YANMAR DIESEL AMERICA CORP.

SERVICE ADVISORY

SUBJECT: Hard Starting

MODELS: 3GM30 Series

FIGURE 1

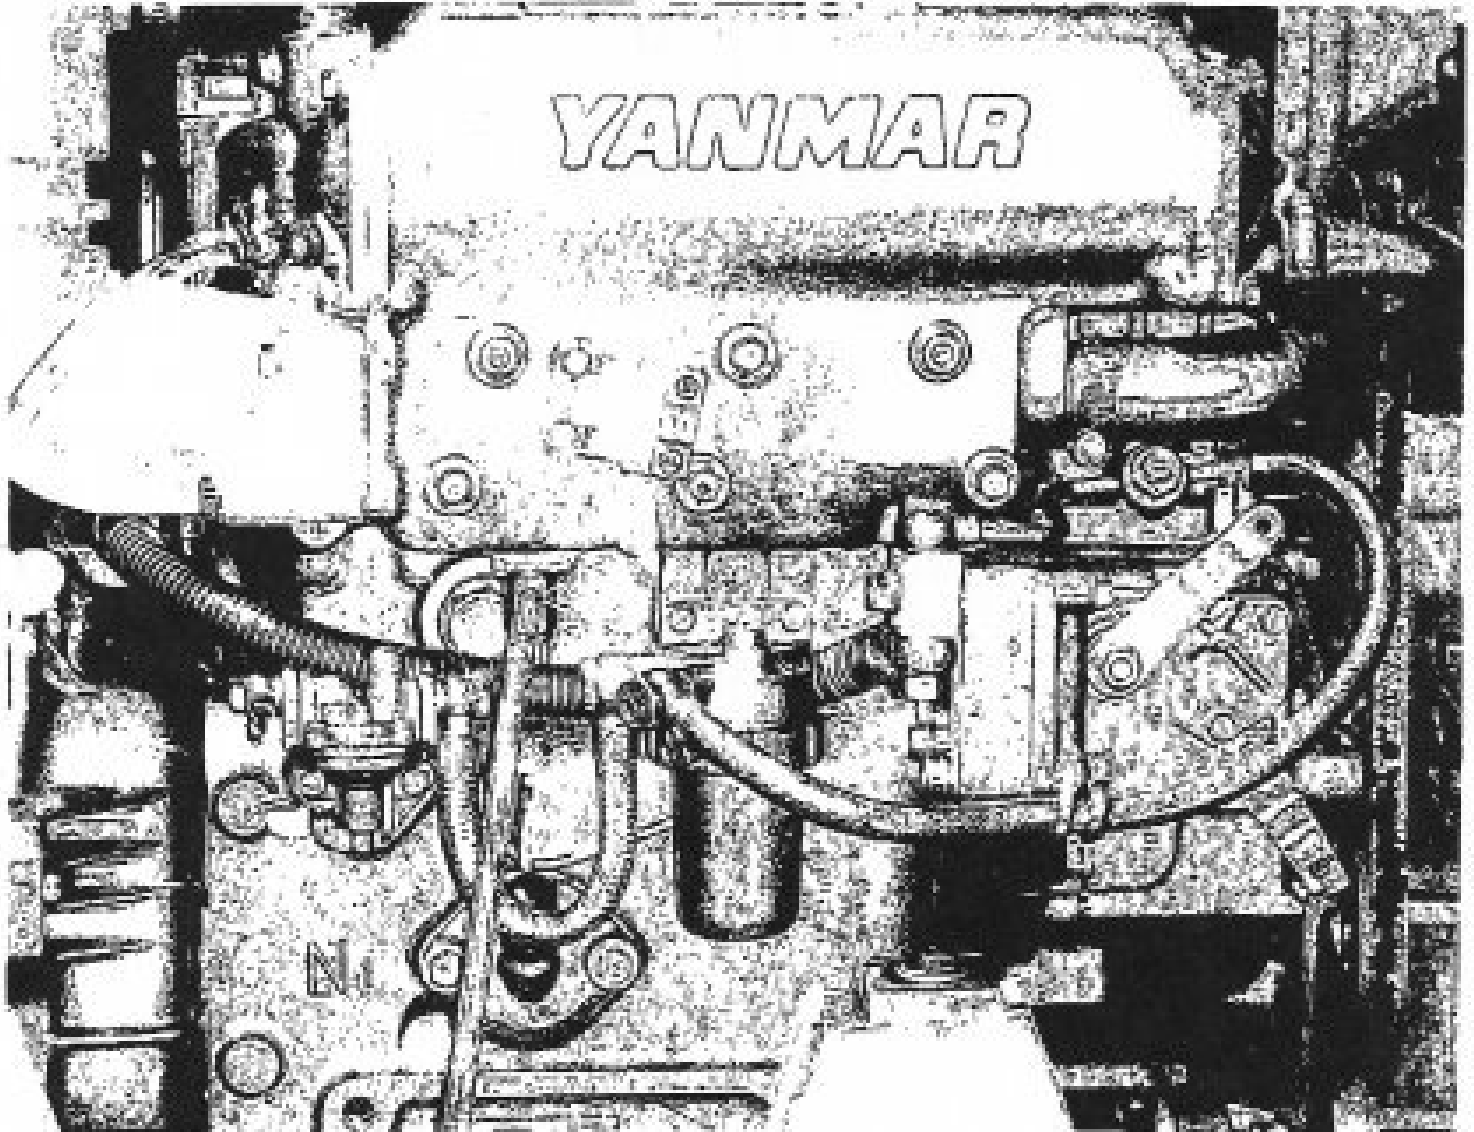
We have received reports of later model 3GM30 models that are hard starting, particularly after not being operated for a period of time. The cause of this problem appears to be a failure of the check valve, p/n 128296-59940, in the fuel line between the fuel feed pump and the fuel injection pump. [See Figure 1] The check valve can "dry out" and either allow air to enter the fuel system or allow fuel system pressure to "bleed off" into the fuel return system.

To correct this problem, we recommend you remove the late model fuel line and check valve assembly, p/n 119173-59120, [See Figure 1], connecting the fuel feed pump to the fuel injection pump and replace it with the earlier style fuel line, p/n 28390-59010. [See Figure 2] Replace the long bolt that secured the check valve housing with a new shorter bolt, p/n 26106-080142. Be sure to use new sealing washers, p/n 23414-120000, when installing the new fuel line.

FIGURE 3

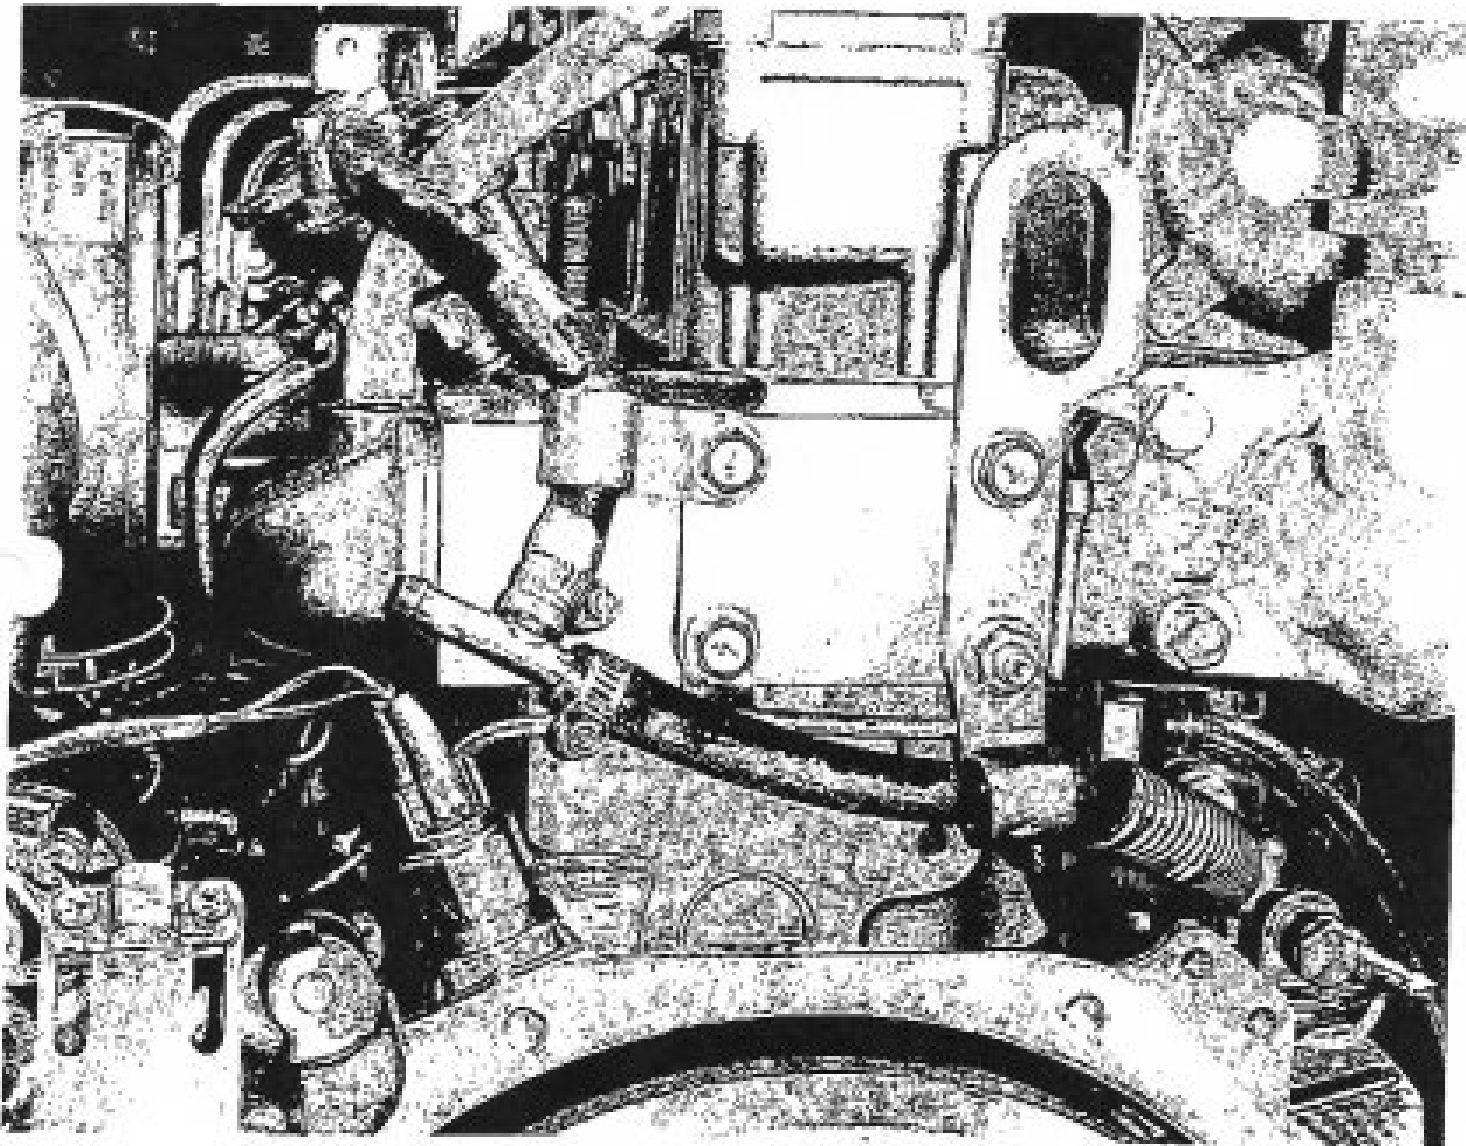
It will also be necessary to remove the fuel return line that ran from the check valve housing to a "Tee" fitting that connected this return line to the return line coming from the fuel injectors. [See Figure 3] Remove the return line, the "Tee", and the short hose from the "Tee" to the output nipple on the fuel injector return line. Connect the fuel tank return line directly to the output nipple on the fuel injector return line. [See Figure 4]
